April 30, 2021

Linda Ruffing  
 Planning Consultant/City of Healdsburg  
 401 Grove St.  
 Healdsburg, CA

The following are responses to the comments received from the City of Healdsburg Planning Commission Workshop on April 13, 2021

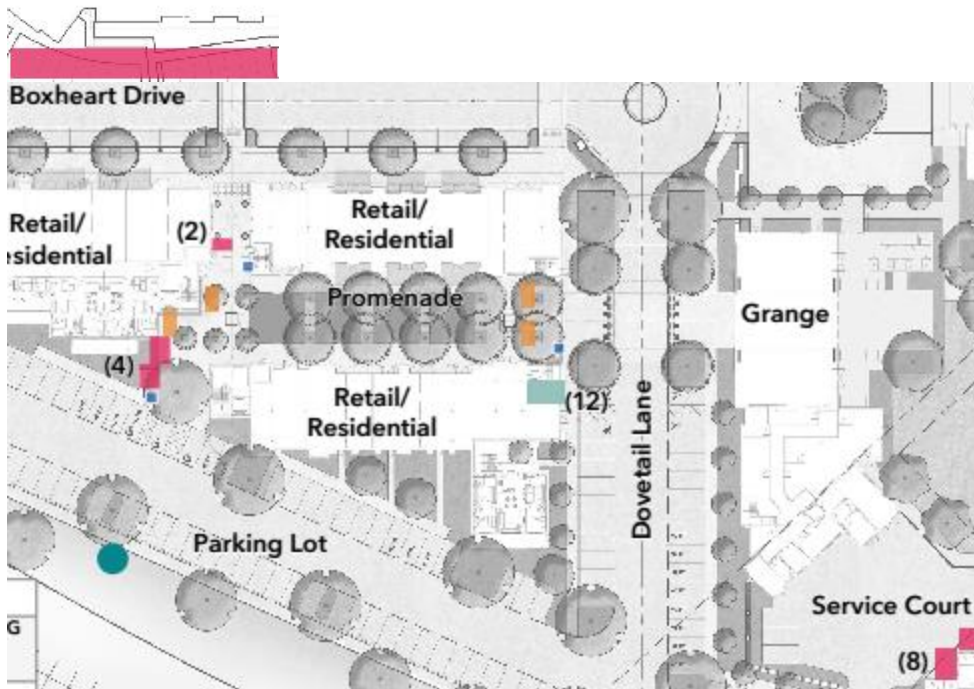
**3. Identify locations for bike storage and number of bikes accommodated.**

HMC Section 20.16.175 establishes that bicycle parking requirements are applicable to the project. The California Green Building Standards Code (CALGreen) identifies requirements re: number of short-term and long-term bicycle parking spaces. Please have your design team prepare an exhibit and narrative providing clarification regarding how bicycle parking standards are met for Parcel 3 and Parcel 4.

- SEE SHT L-1.28
  - Bike Storage matrix added per CalGreen.
  - Bike Rack specification provided.
  - Additional Bike Storage locations shown.

BIKE PARKING CALCULATIONS				
	PARKING SPACES	CALGREEN STANDARDS	BIKE PARKING SPACES REQUIRED	BIKE PARKING SPACES PROVIDED
Short Term Visitor Parking	73	5%	3.7	6
Long Term Secure Parking: Retail Tenant/ Retail Employees Residents	5 64			
TOTAL	69	5%	3.5	12
Long Term Secure Parking: Hotel Employees	31	5%	1.6	8

**Bike Racks**  
**Quantity: (14) Total**  
 Forms+Surfaces  
 Capital Bike Rack  
 Texture Powdercoat  
 Finish - Argento

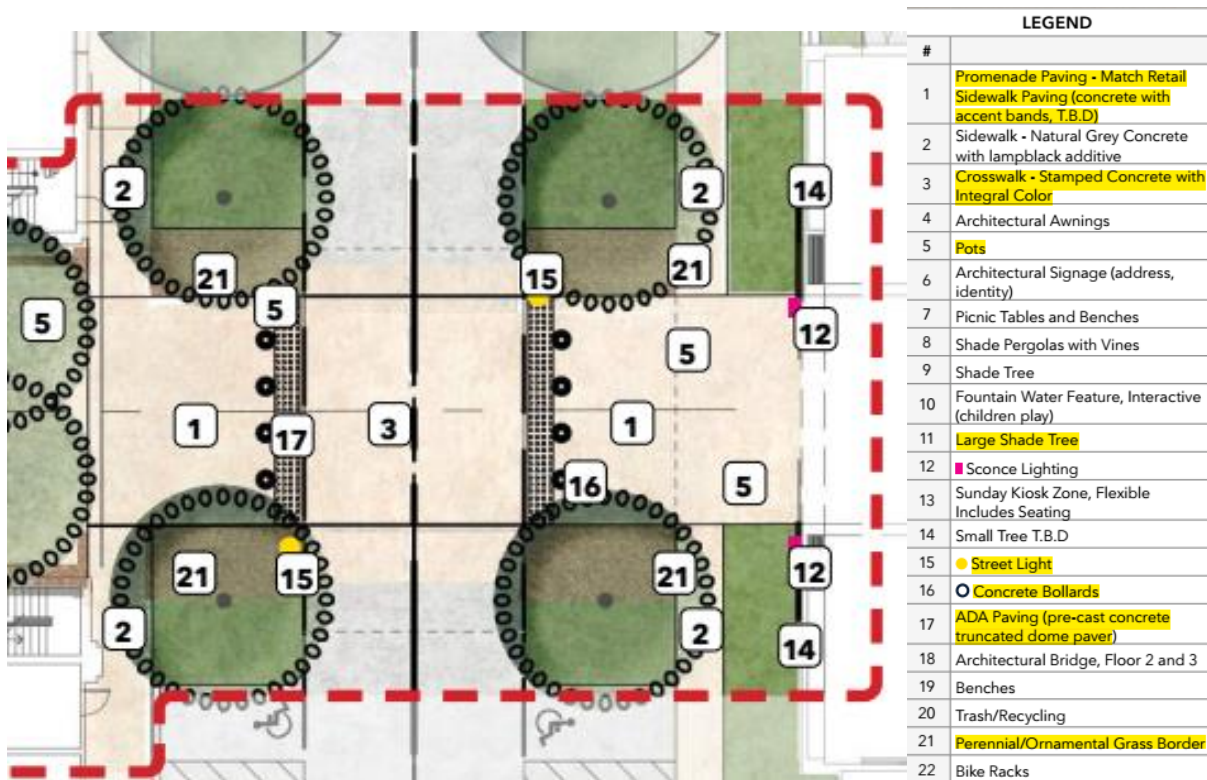
### **14. Connection from Promenade to Grange.**

Please provide an illustration highlighting the special treatment of the pedestrian connection between the Promenade and the Grange (i.e., decorative, colored concrete, raised crosswalk, truncated domes, bollards, street lighting, etc.).

- *Refer to Sheet L-1.26. Also refer to Perspective Sheet A-1.15.*
  - *The crossing and connection between the Promenade to the Grange is visually emphasized by a combination of details to draw attention to this important crossing and connection:*
  - *Decorative colored/texture concrete paving at the sidewalk and elevated widened crosswalk, enhanced with truncated dome pavers at the sidewalk edge as well as decorative bollards and streetlights to enhance safety and traffic calming. Decorative pots and a border of perennials/ornamental grasses provide color and interest flanking the sidewalk areas on either side, as well as large scale shade trees. Night-time lighting of the Grange and Promenade entrances are designed to create a welcoming glow.*
